Irish Air Line Pilots' Association

IALPA Submission to CAR Re: PACE Supplementary CIP projects.

"Response to Draft Decision on the Second Interim Review of the 2014 Determination"

Fig 7: Introduction of a zig-zag for preventing runway incursion

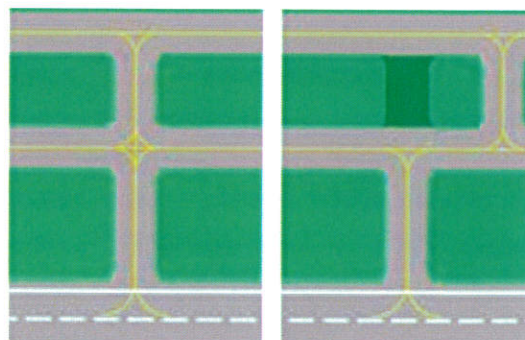
As runway 16-34 is an operational runway at EIDW we naturally have concerns particularly at para (c) which clearly states that "The initial approach should be to reduce the number of available entrances to the runway, so that the potential for entry to the runway at an unintended location is minimised....."

Whilst best practice as (outlined in Page 124 of the EAPPRI V3.0 :European Action Plan for the Prevention of Runway Incursions) seeks to mitigate against these type of DAA straight / direct runway access proposals at LINKS 3,6, and Realigned Taxiway A.

A Zig /Zag pattern is the safest design as indicated below.

Long, straight taxiways accessing to or crossing runway should be avoided, or replaced by 'zig-zags'.

For example, move from the 'straight' configuration on the left to the 'zig-zag' configuration on the right.
